DESCRIPTION Expansion Dam Detail
PROJECT Sandy River Bridge Proj. No. BH-025-2(46)
LOCATION New Sharon, Me.
DESIGNER Me. D.O.T.
CUSTOMER Callahan Bros., Inc.
JOB NO. 89-670-4
DWG. NO. 22
REV. ②

STATE OF MAINE
DEPARTMENT OF TRANSPORTATION
☒ Approved ☐ Returned for Corrections
AUG 16 1989
☐ Approved as noted ☐ Rejected
K. Jacobs
WELDING ENGR.

DESCRIPTION SPLICE PLTS FOR LINK RETROFIT
PROJECT SANDY RIVER BRIDGE PROJ. No. BH-025-4(26)
LOCATION NEW SHARON, ME
DESIGNER ME DOT
CUSTOMER CALLAHAN BROS.
JOB NO. 89-670-2   DWG. NO. 1   REV. (A)

Plan @ Pier #1

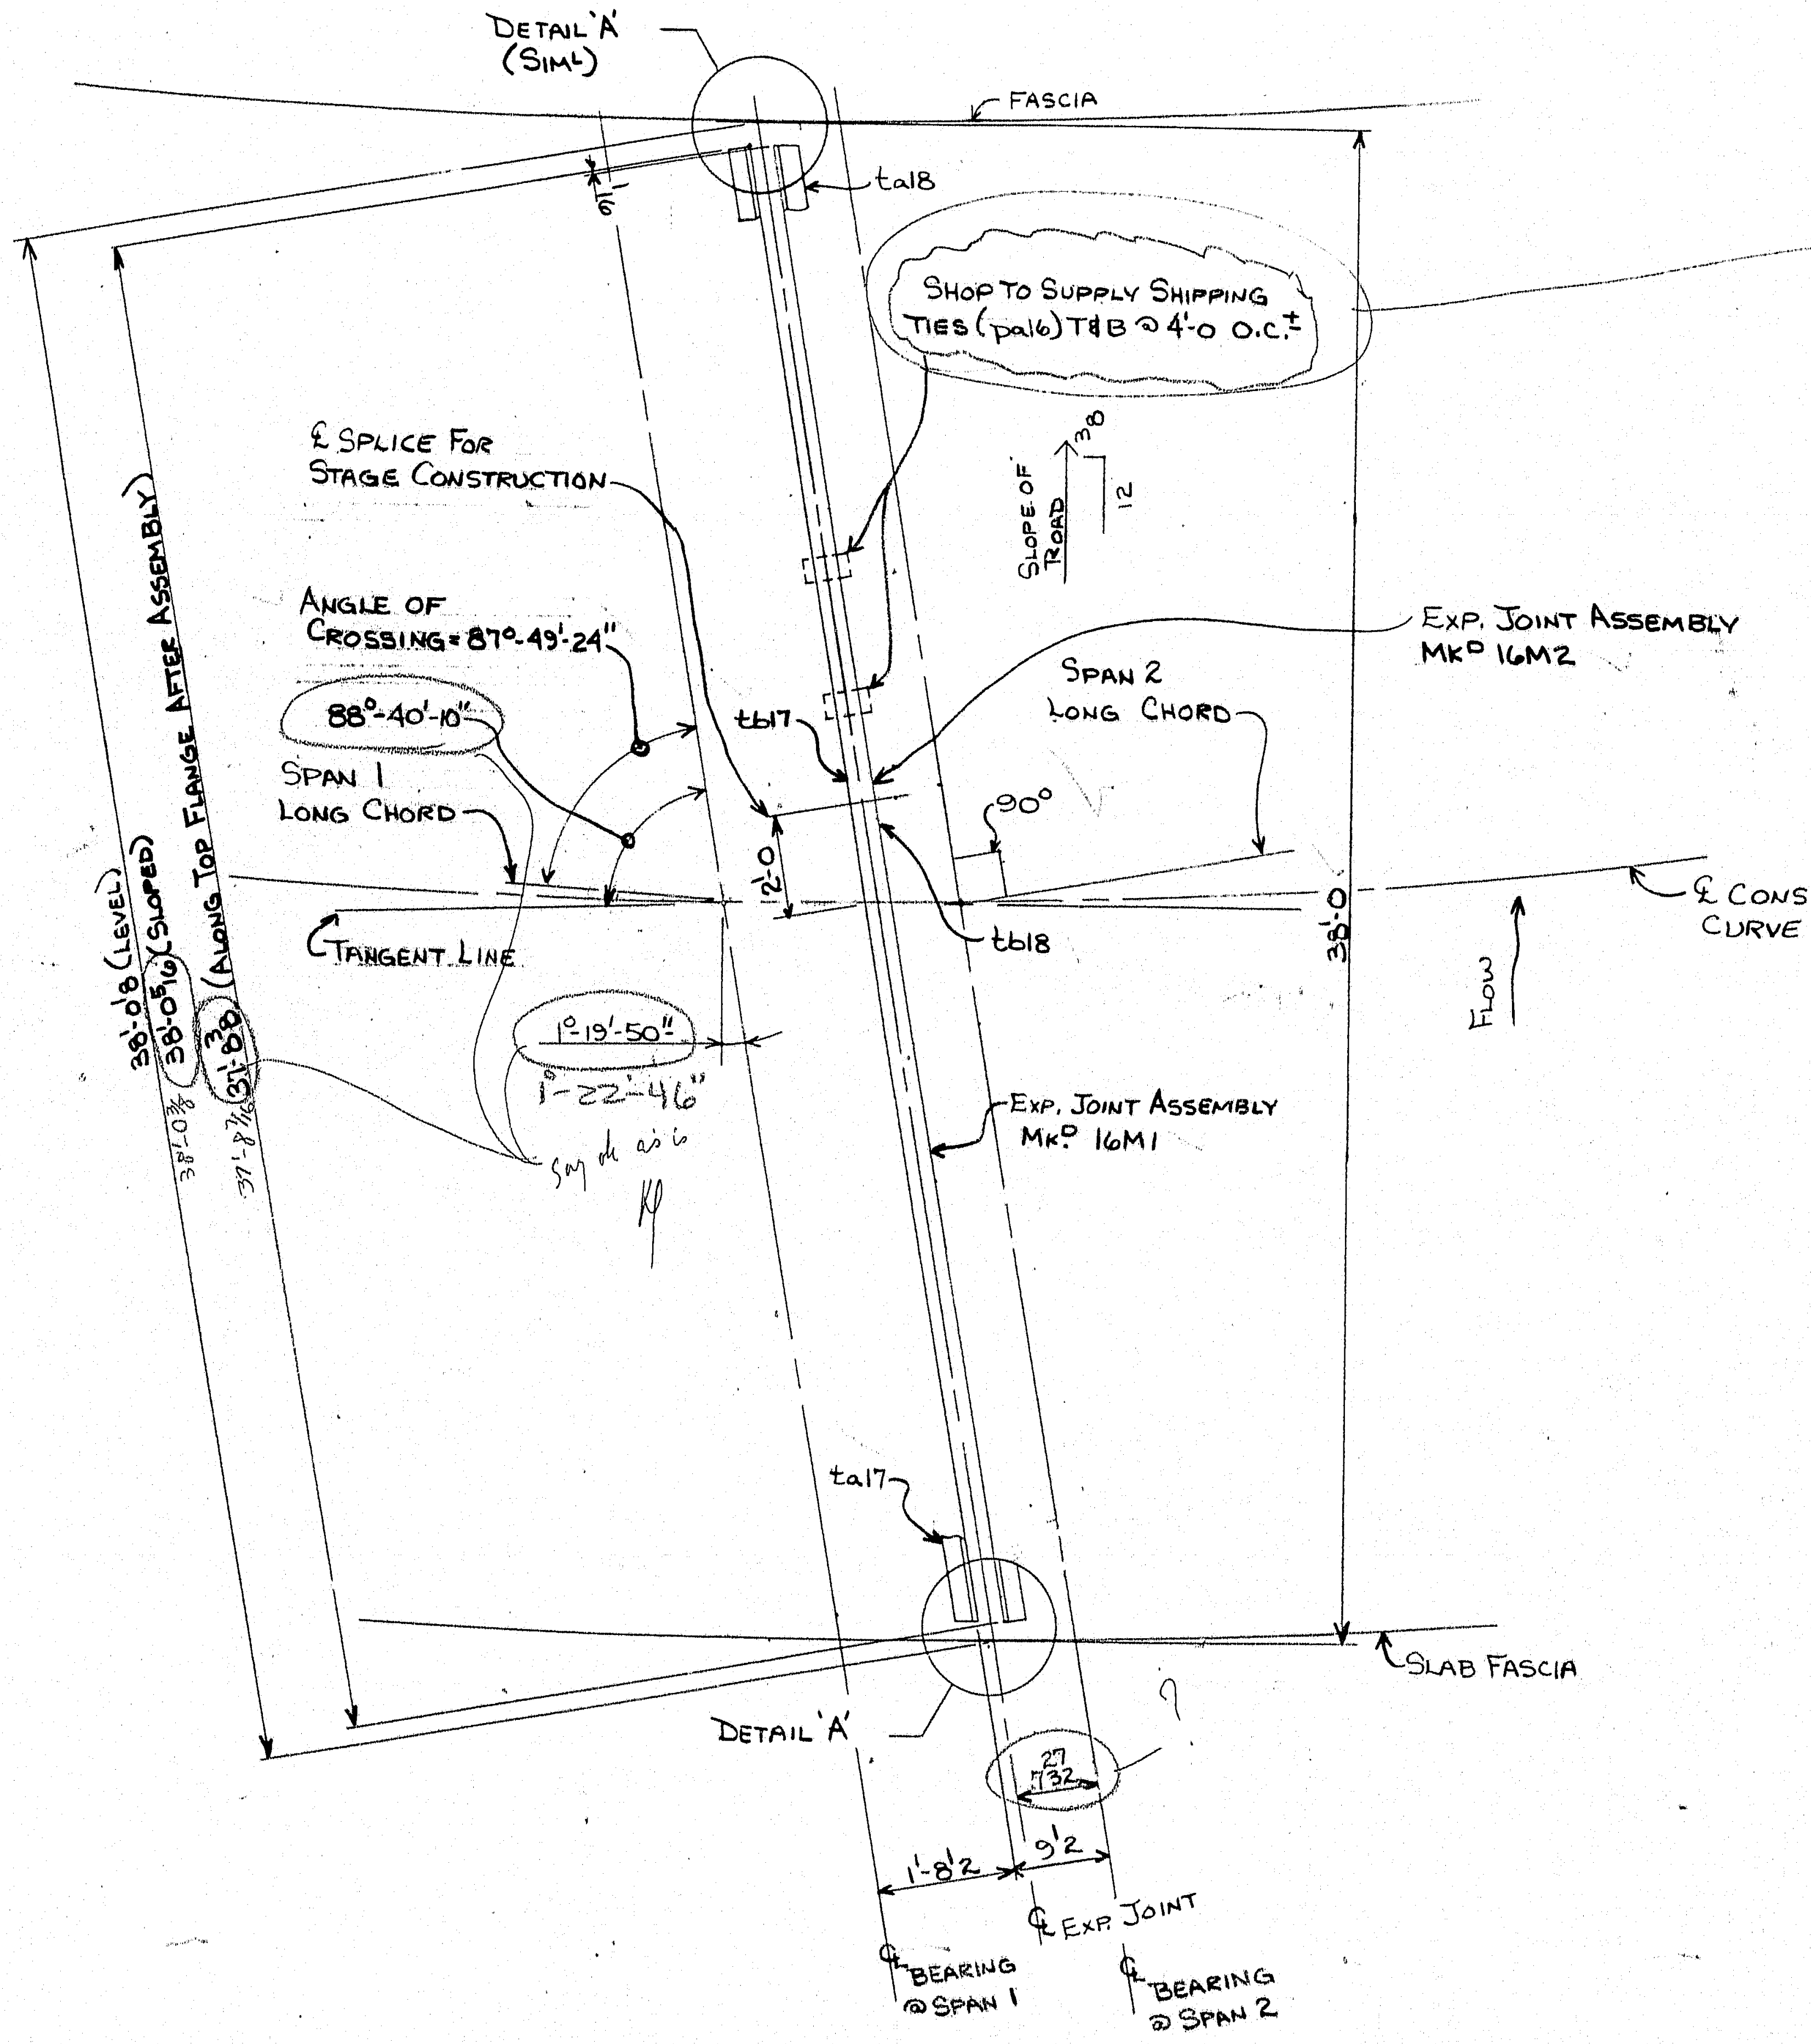
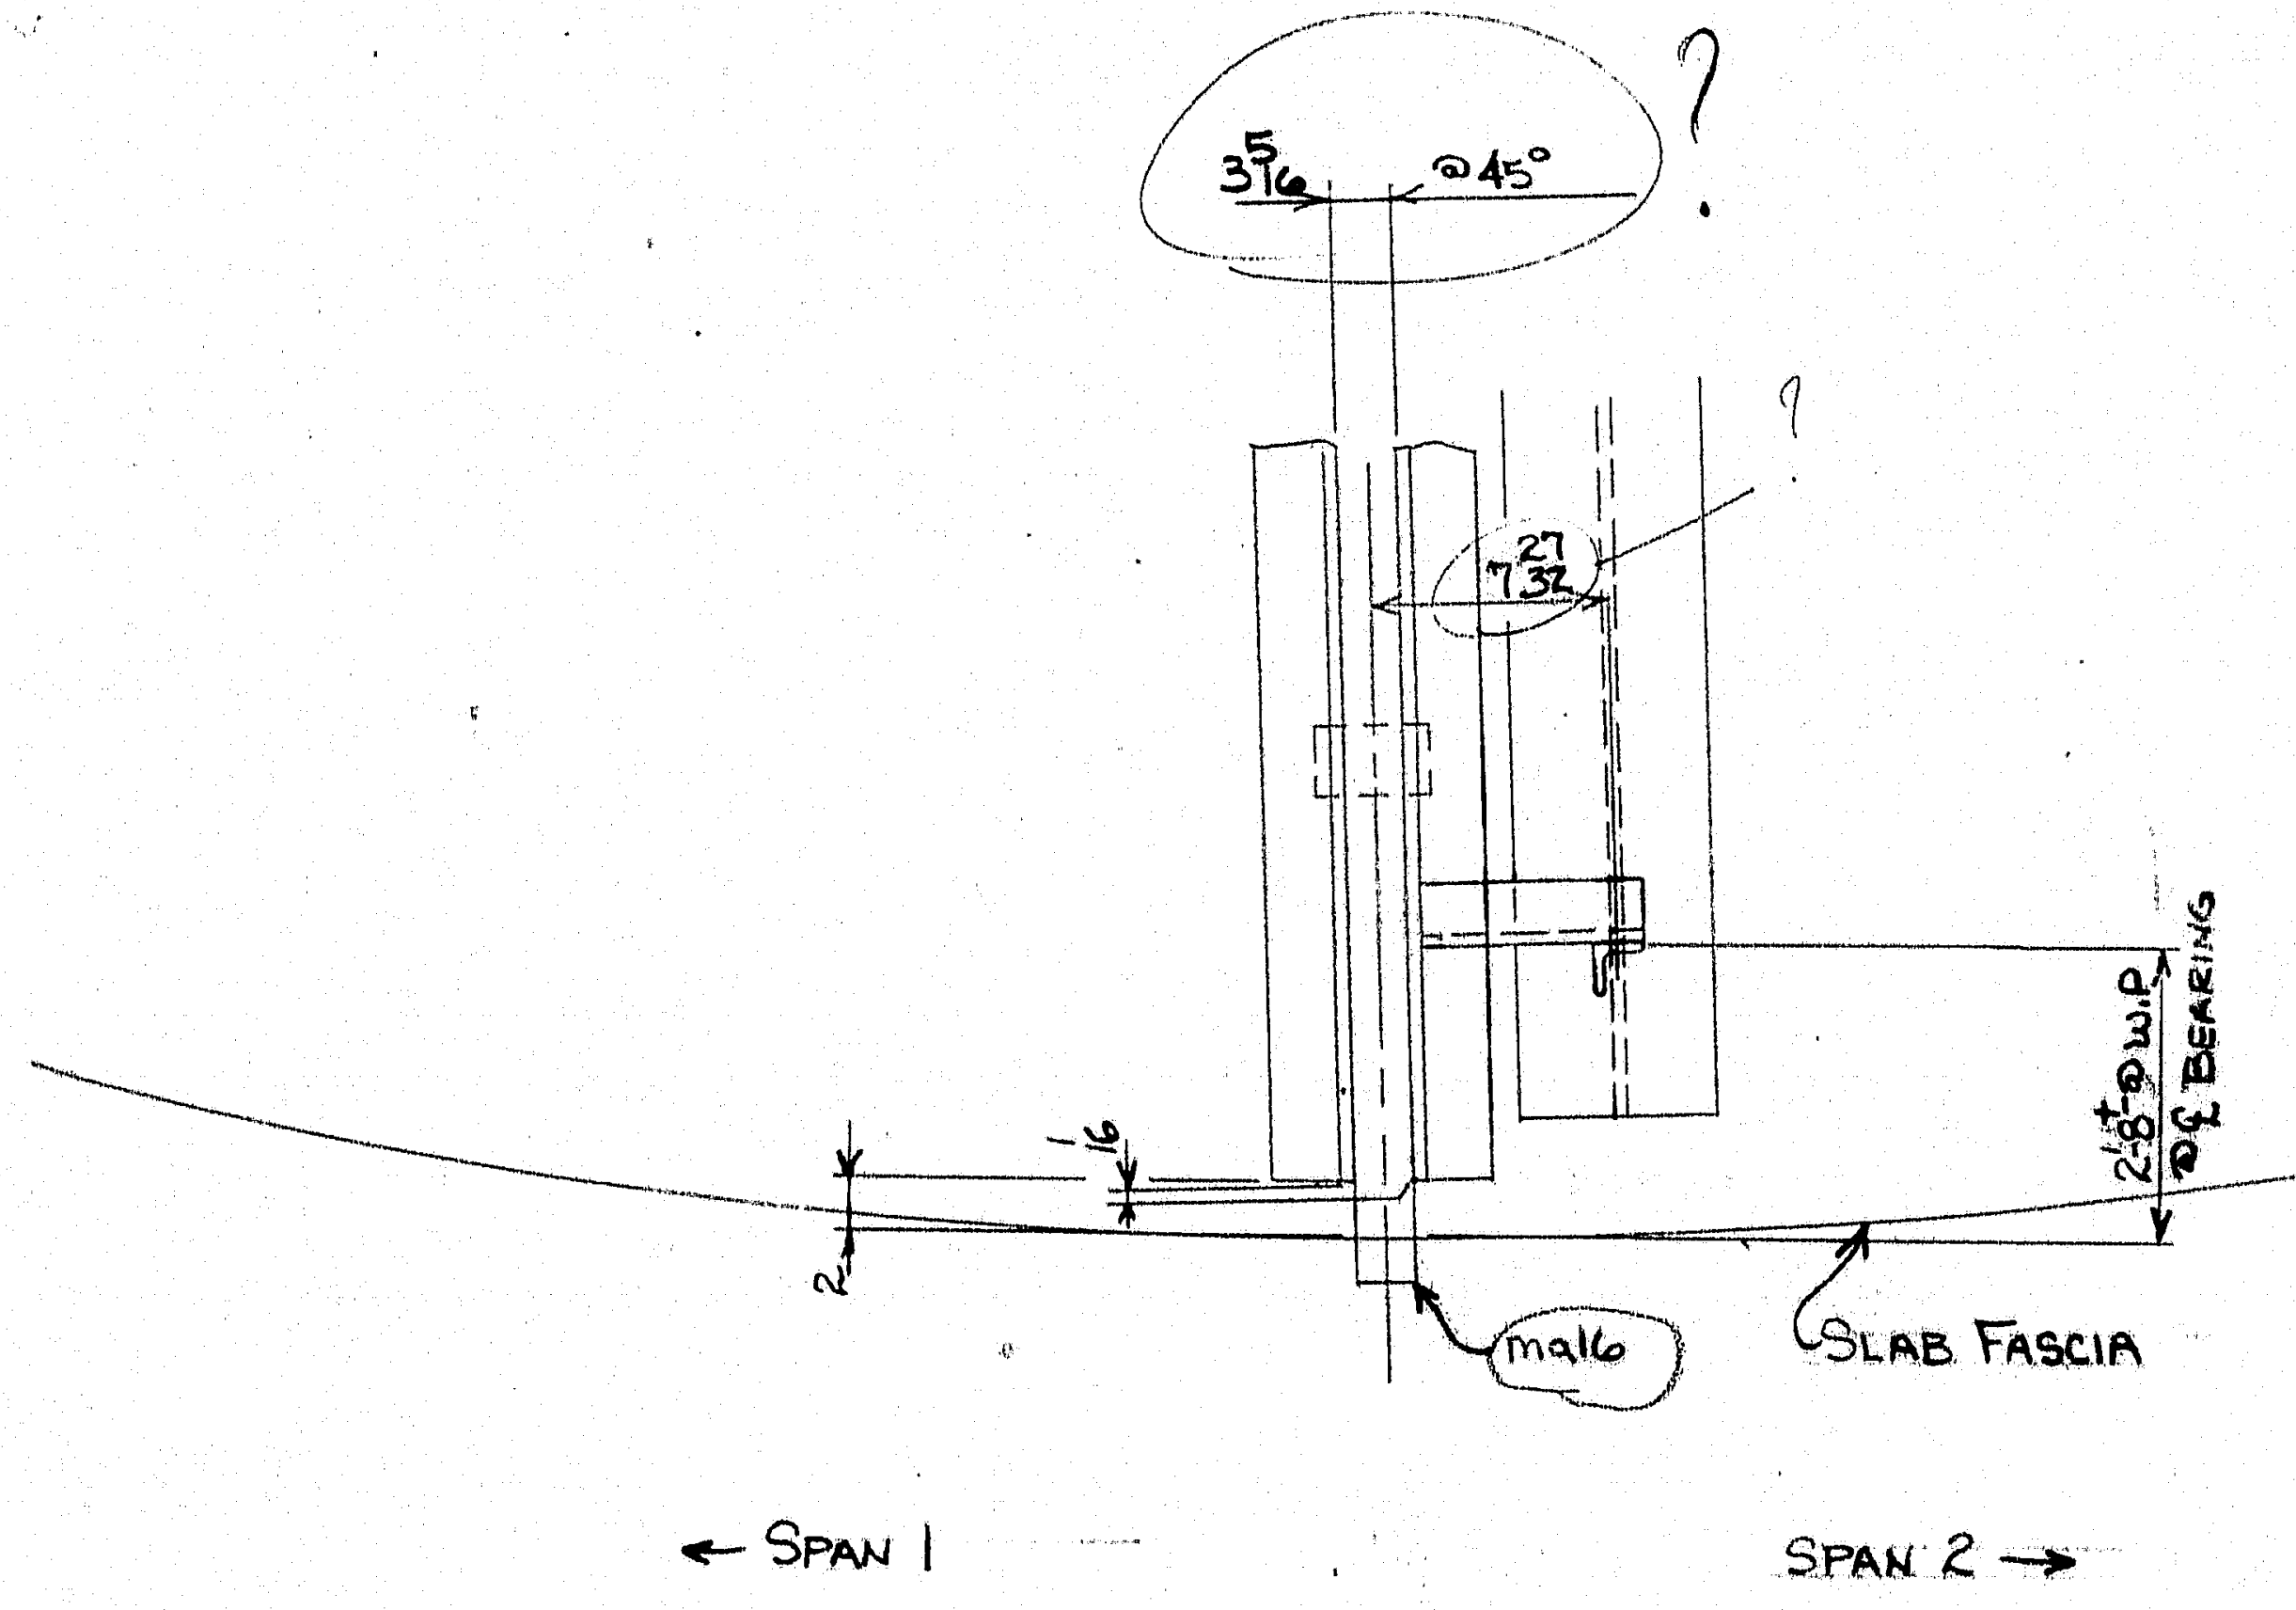
No!!! If used, shipping devices must be adjustable, ~~[illegible]~~ that needed for stage construction however

DESCRIPTION GLAND SEAL @ PIER #4
PROJECT SANDY RIVER BRIDGE PROJ. NO. BH-025-2(46)
LOCATION NEW SHARON, ME
DESIGNER ME.D.O.T.
CUSTOMER CALLAHAN BROS., INC.

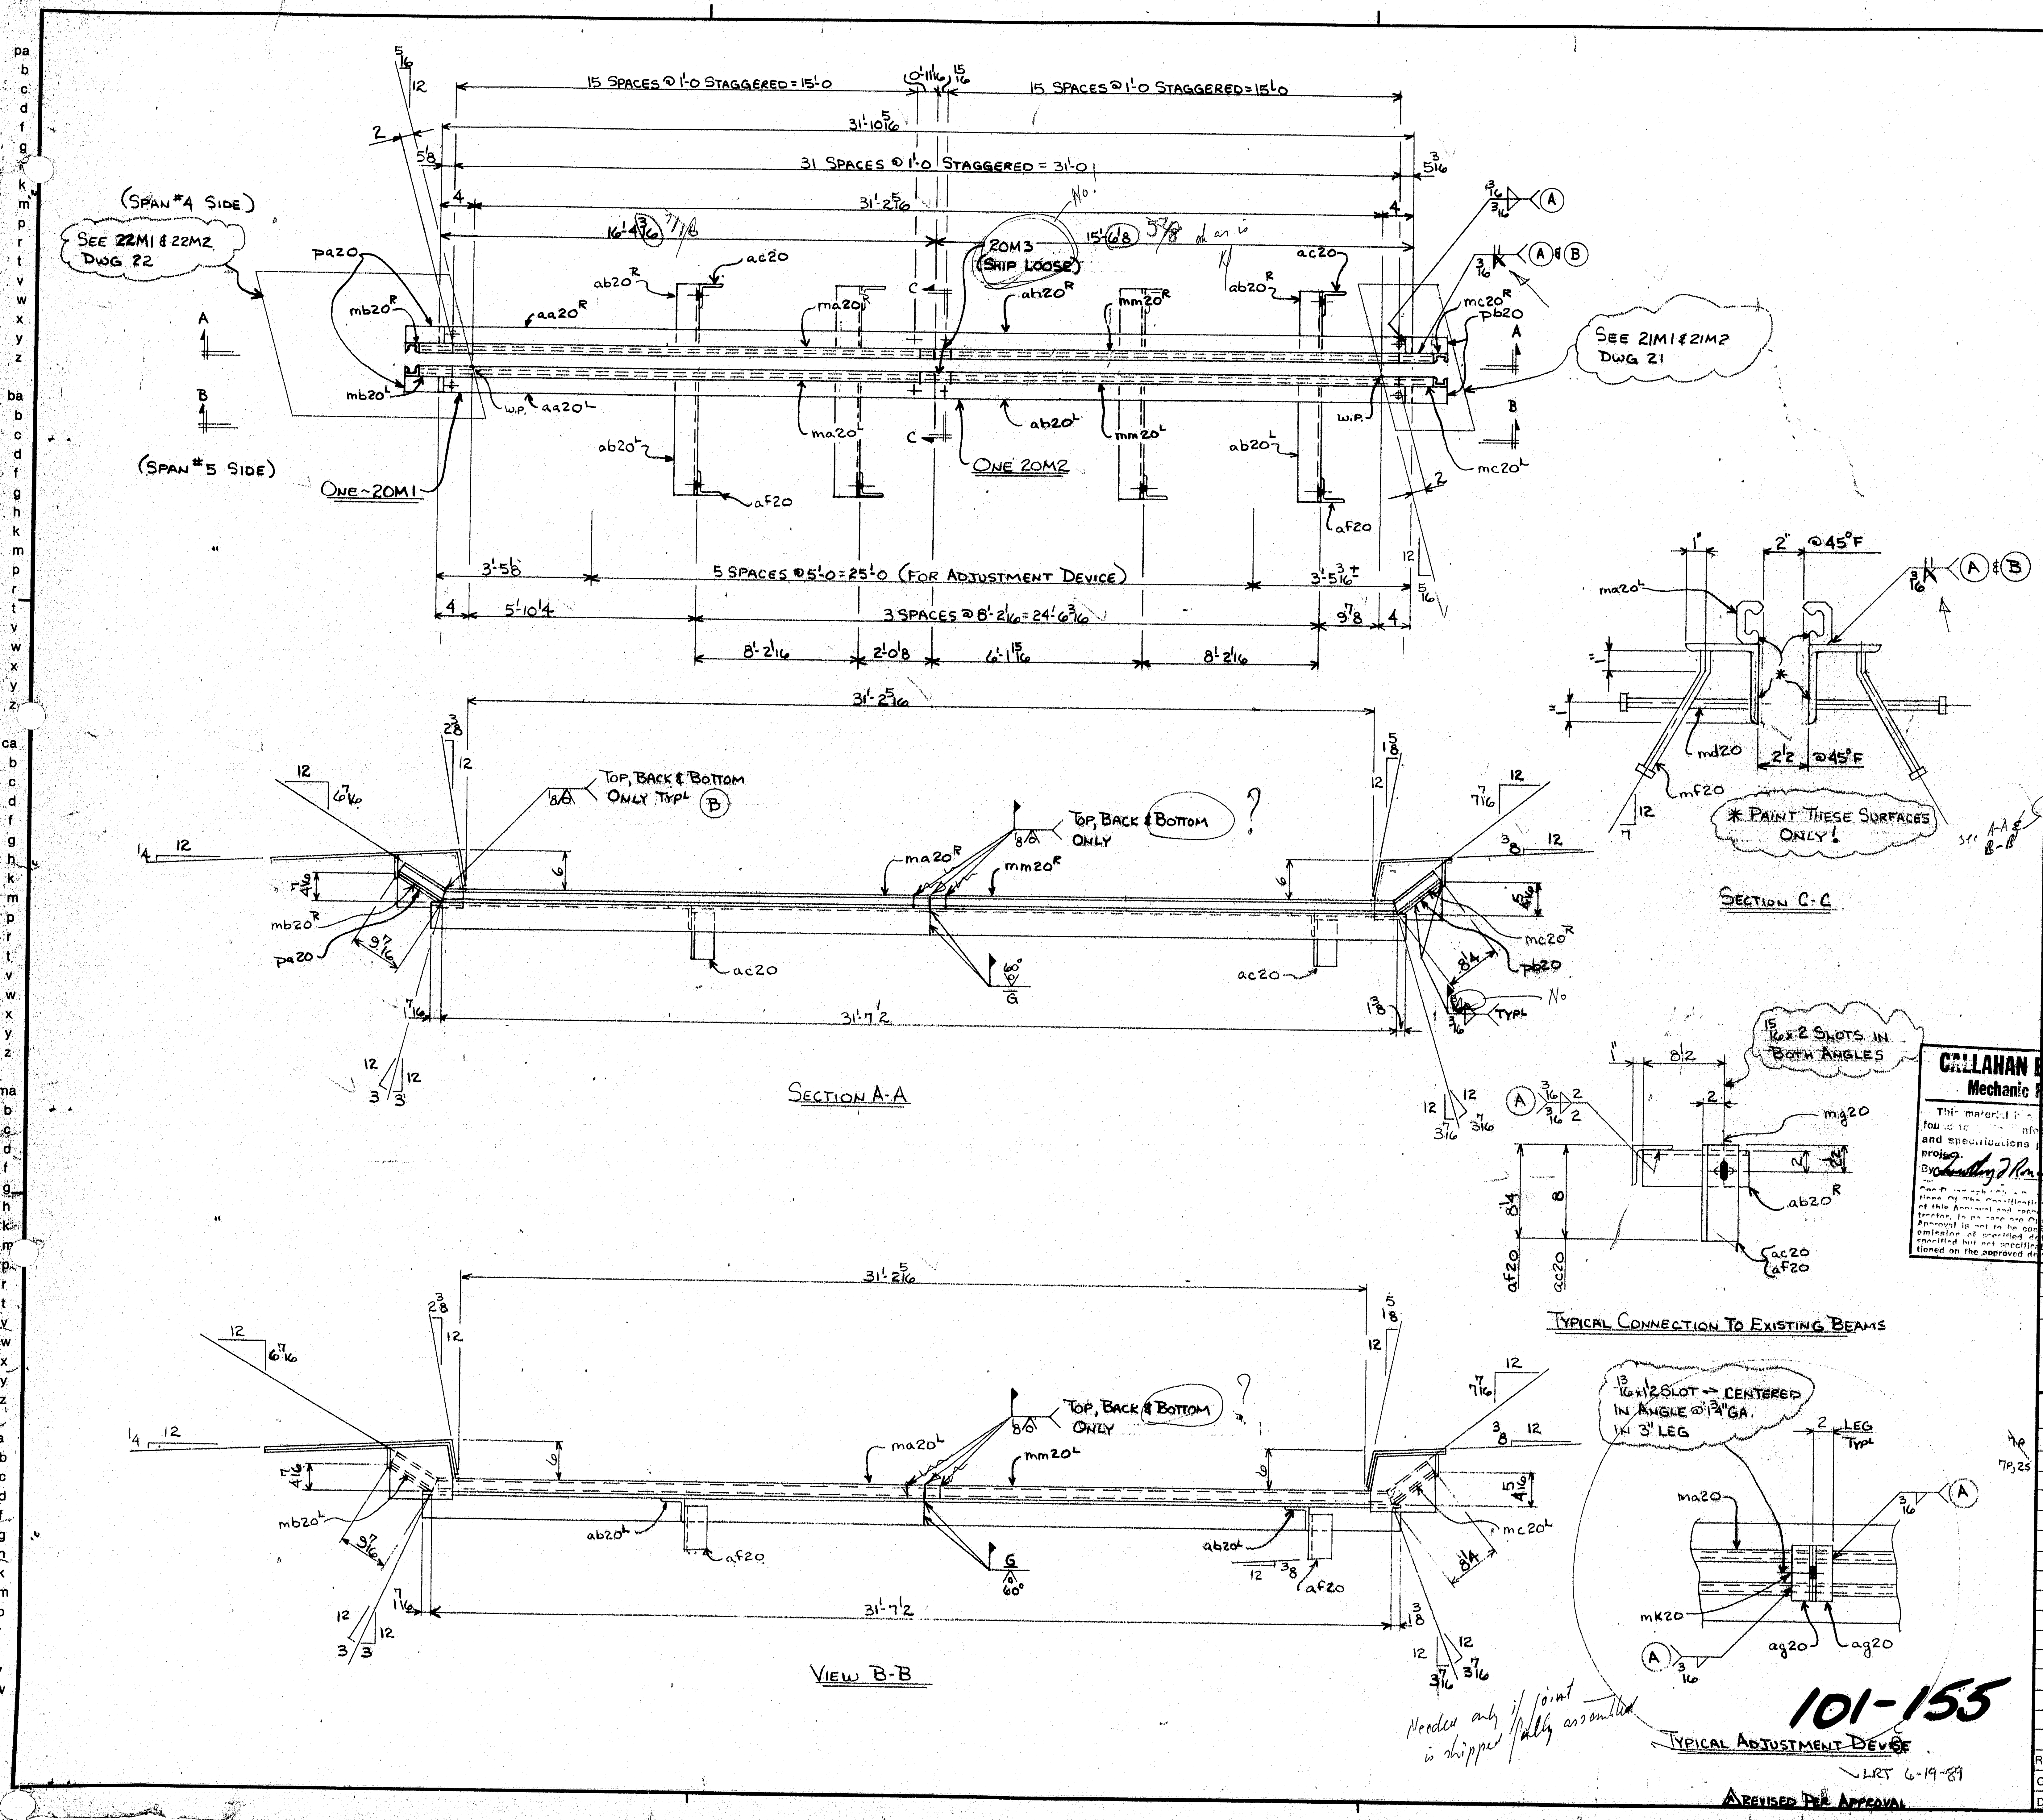
Needed only if joint is shipped fully assembled
